NUMBER: 83-1

- A. Starter Motor Pinion Gear/Flywheel Tooth Ratio * V6 Outboards
- B. Carburetor Main Jet Gaskets * V6 Outboards
- C. Thread Stripping * Transom Mounting Bolts
- D. Recommended Flushing Procedure for Mercury Outboards * Merc 18 thru V300

Nut, Transom Mounting

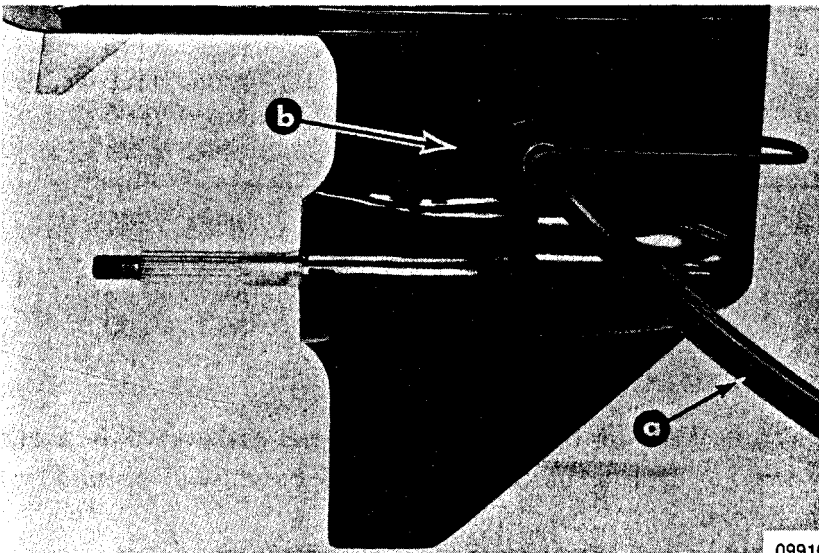
Due to a thread stripping problem when installing the transom mounting bolts on outboards, the material of the nut has been changed from stainless steel to brass. Should you have a thread stripping problem, order the new brass material nuts listed below.

Part No. 11-99405

(supersedes Part No. 11-68411)

Part No. 11-91962

(supersedes Part No. 11-35000)
